Reference: JLTC BLDG #2 Camp Williams
DFCM Project No. 05006480

Subject: **Addendum No. 1**

SECTION 08411 Aluminum-Framed Entrances and Storefronts:

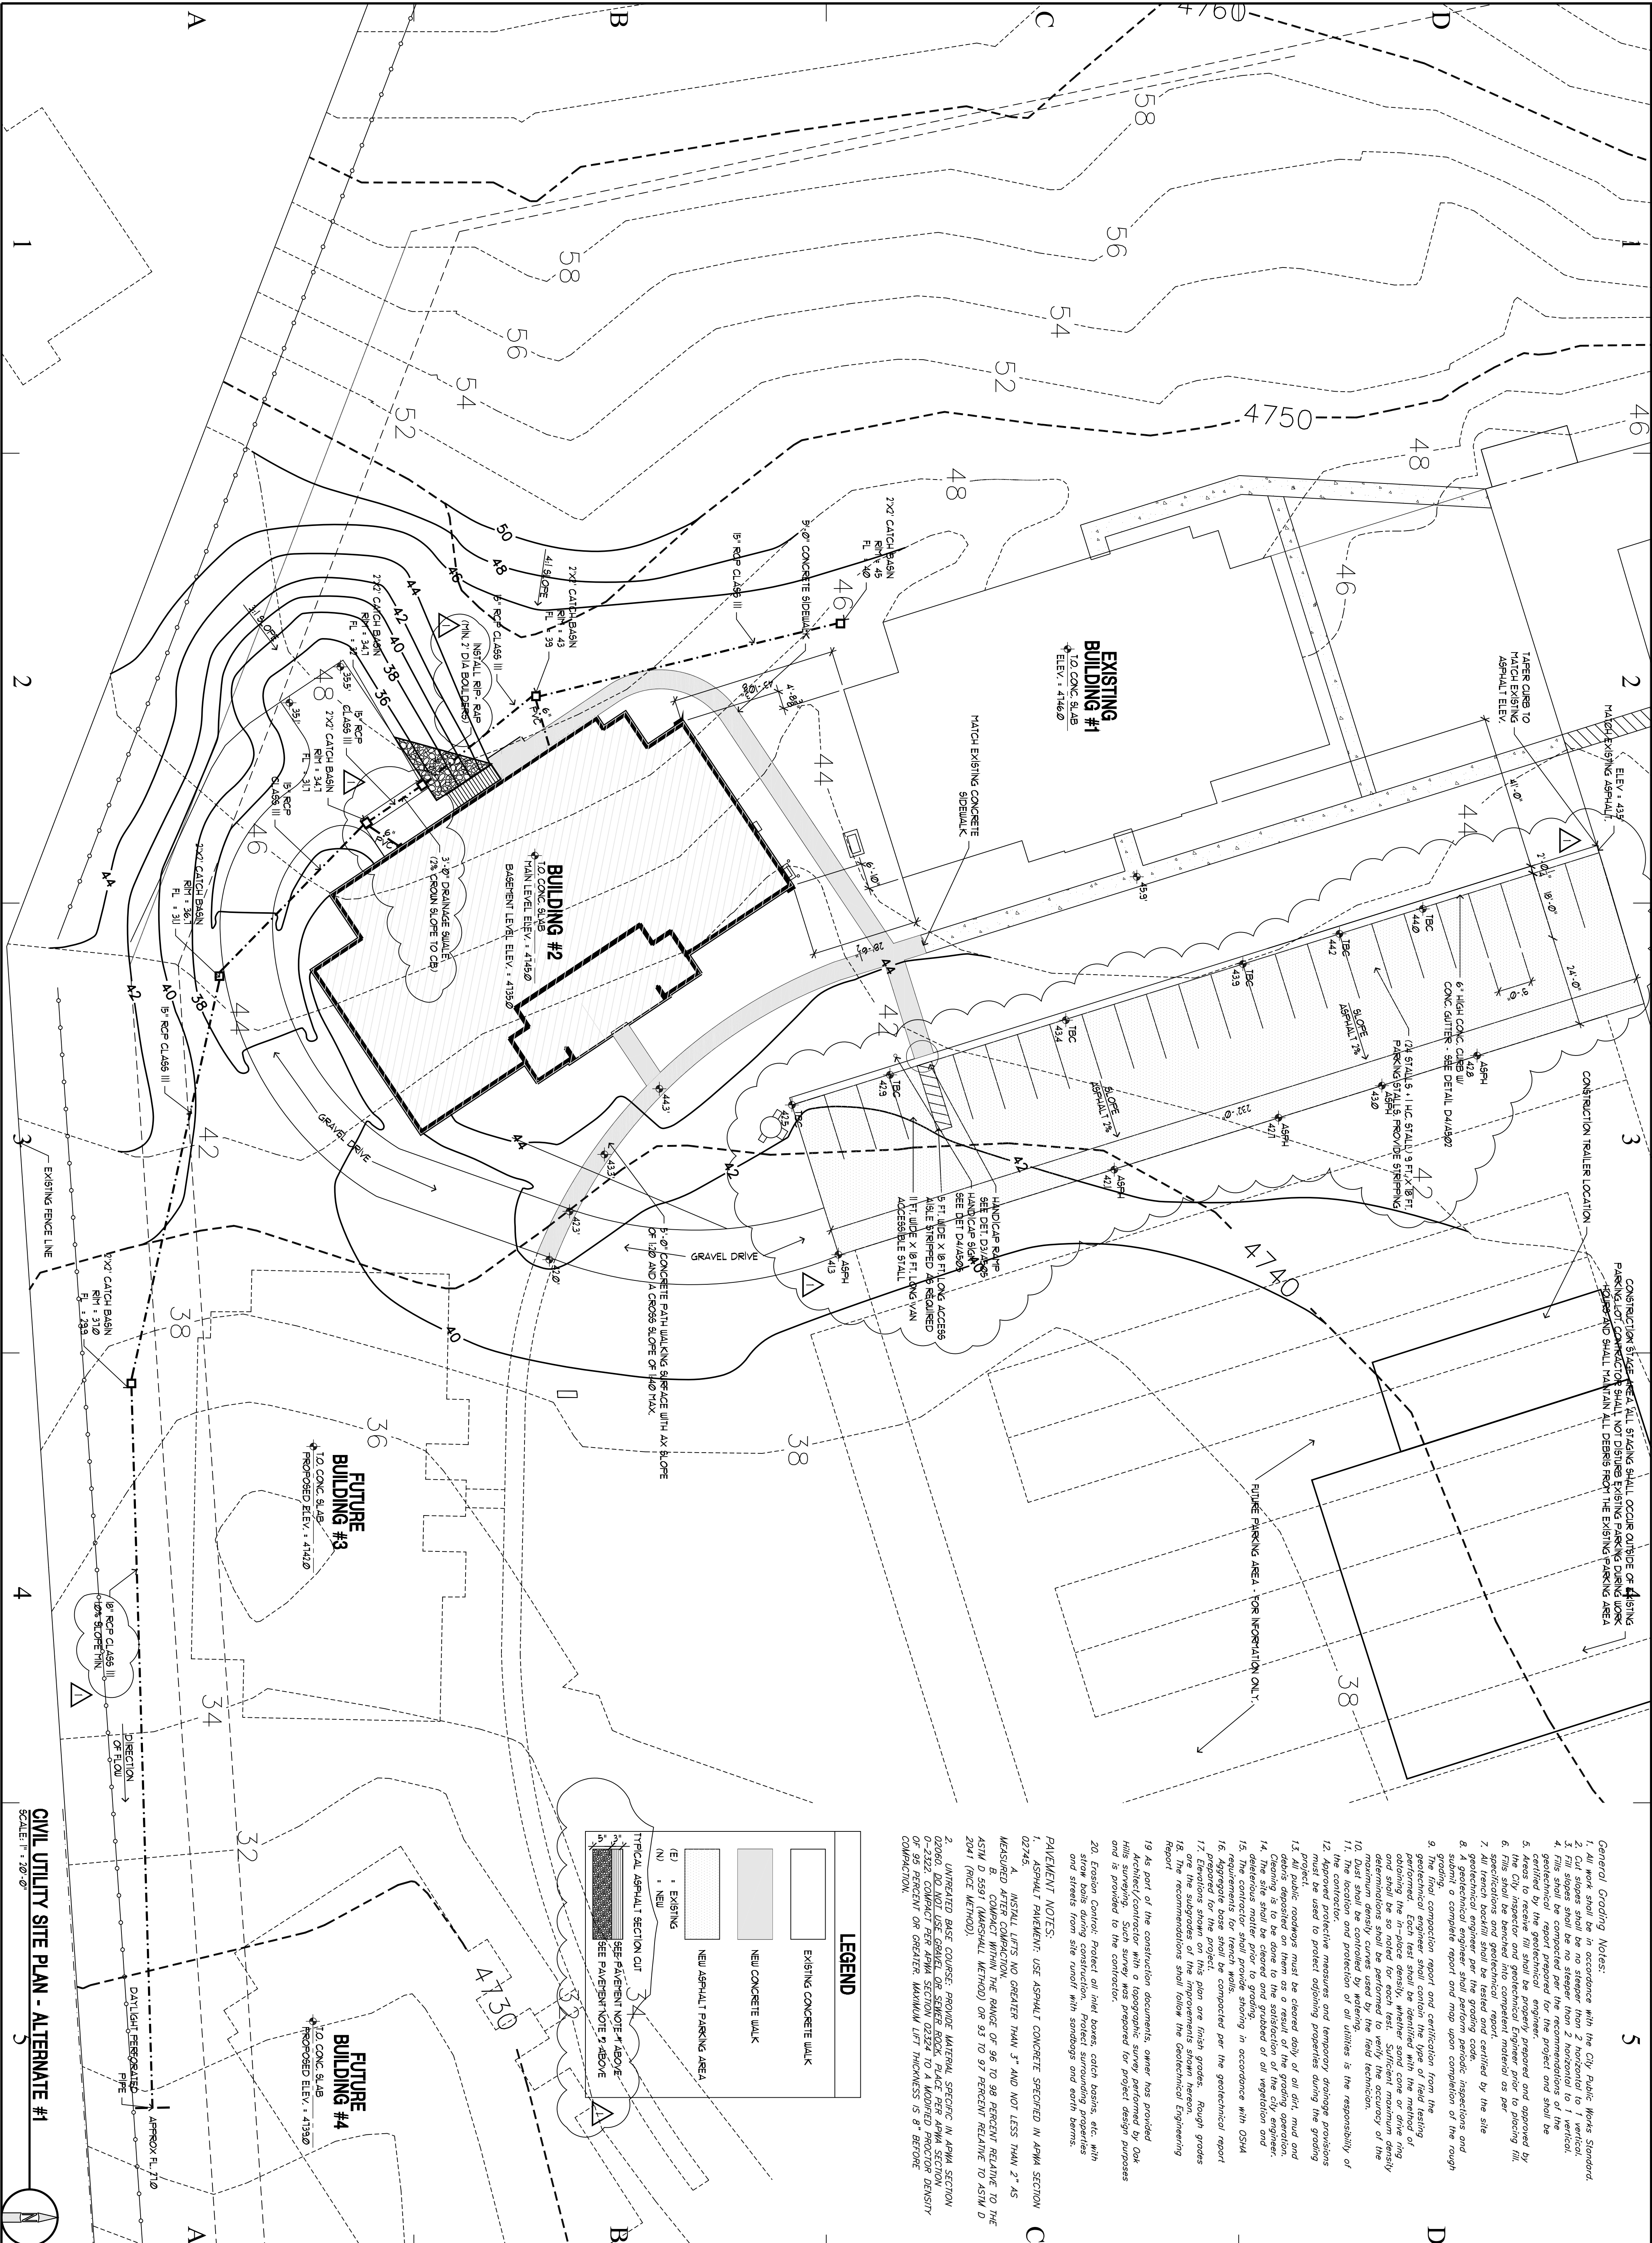
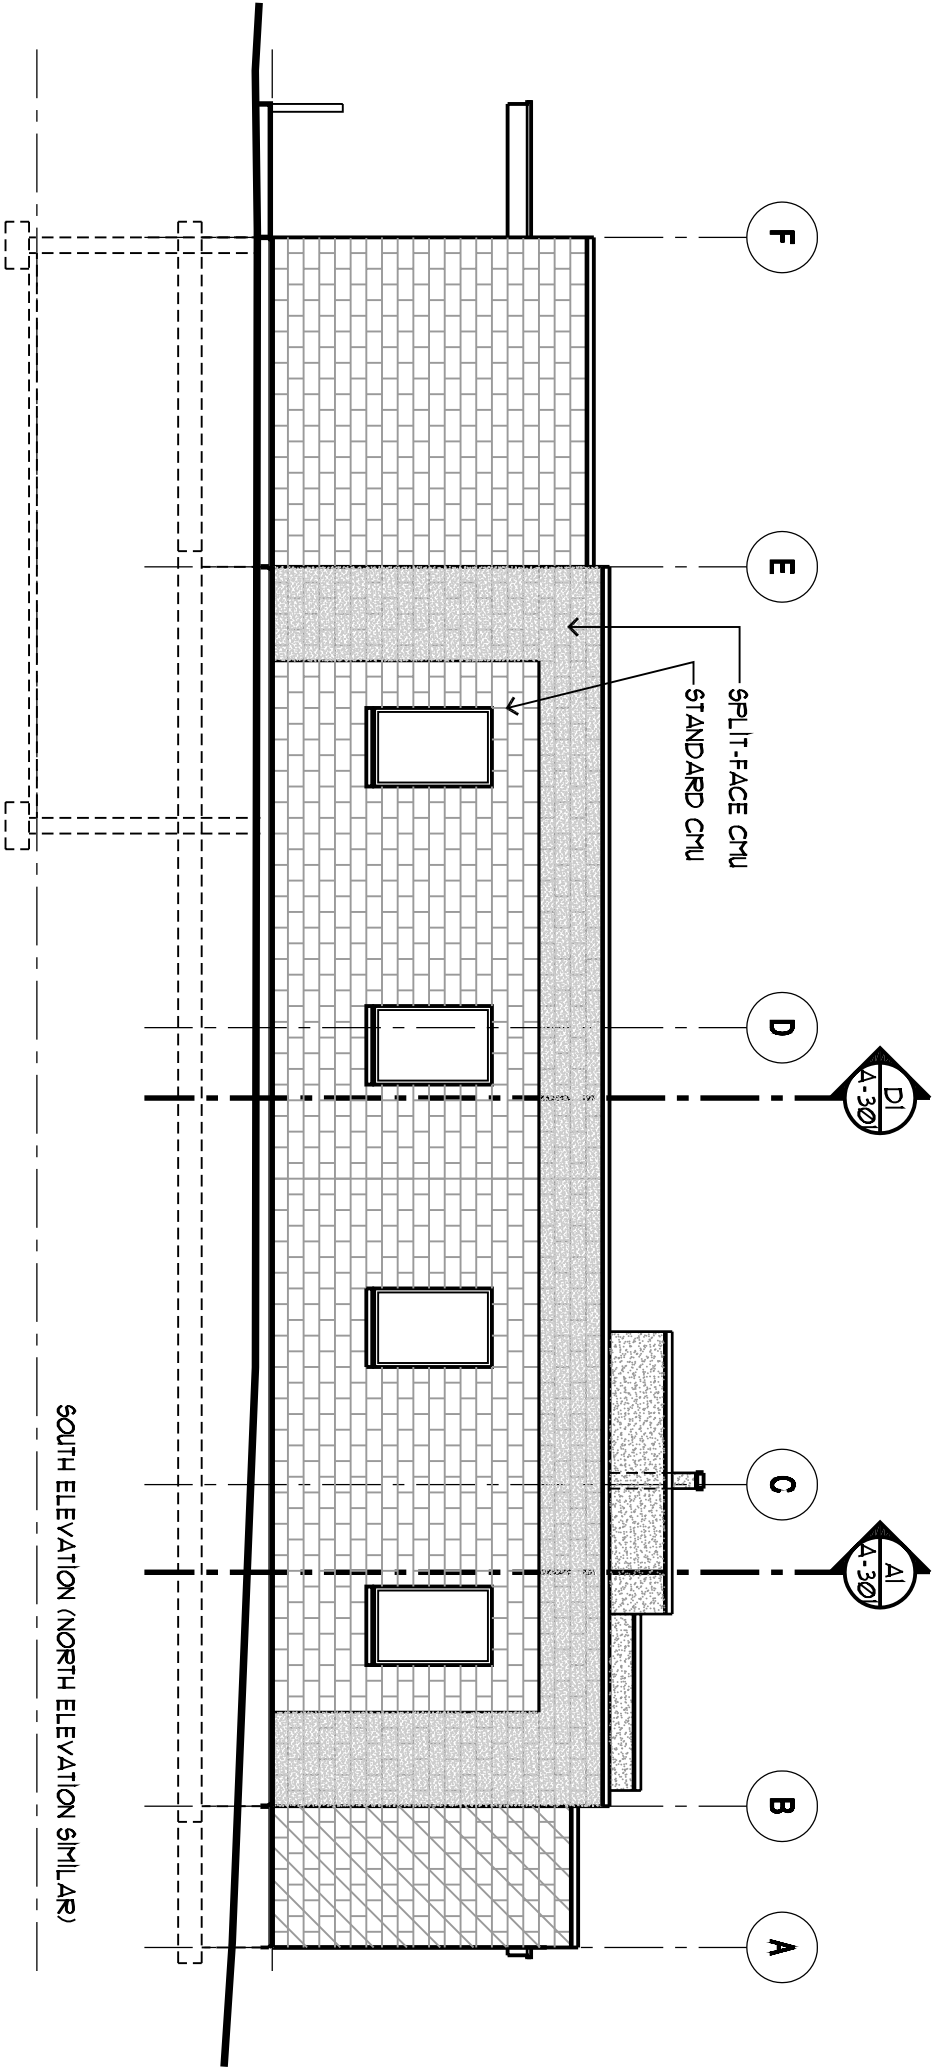
Provide the following materials or equal:

- 1.1.1. US Aluminum Series 400 Medium Stile.
- 1.1.2. 10" Bottom Rails.
- 1.1.3. Finish: Class 1 clear Anodized.
- 1.1.4. Top, bottom and intermediate offset pivots.
- 1.1.5. LCN 4111 Parallel Arm Closer.
- 1.1.6. Jackson 1295 Rim Panics @ Exterior.
- 1.1.7. Provide for blackout for HES 1006 BLK Universal Electric Strike (Southern Lock & Supply Co.).
- 1.1.8. Provide for Cylinder BEST as per state standards.
- 1.1.9. Style PR032 Pull Handle.
- 1.1.10. Style PR031 Push Bar.
- 1.1.11. ½" x 4" mill finish threshold.
- 1.1.12. Bottom door sweeps at exterior.
- 1.1.13. Hardware & Trim Finish- Clear Anodized.
- 1.1.14. 5 year warranty.

SOUTH ELEVATION (NORTH ELEVATION SIMILAR)

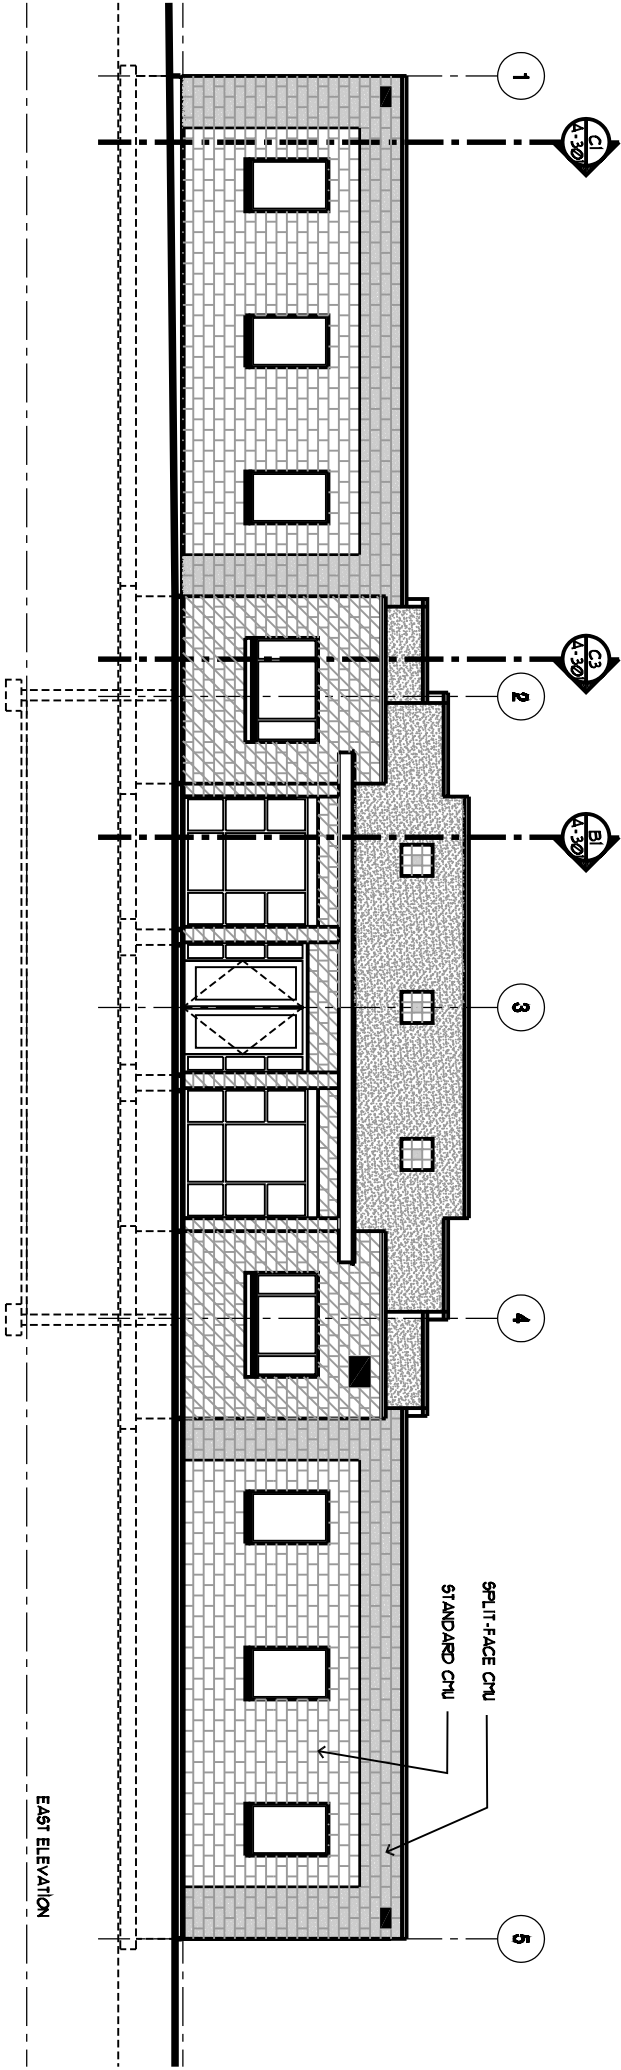
- 2. SHEET C-501 Civil Details:
 - 2.1. Omit this sheet as details do not apply to this job.
- 3. SHEET C-101 Base Bid Grading Plan:
 - 3.1. Clouded areas indicate changed information.
- 4. SHEET C-101A Alternate #1 Grading Plan:
 - 4.1. Clouded areas indicate changed information.
- 5. SHEET C-102 Civil Utility Plan:
 - 5.1. Clouded areas indicate changed information.
- 6. SHEET A-201 Exterior Elevations:
 - 6.1. East Elevation: (attached) darker shading clarifies extent of split-face cmu.
 - 6.2. South Elevation with North Elevation similar: (attached) darker shading clarifies extent of split-face cmu.
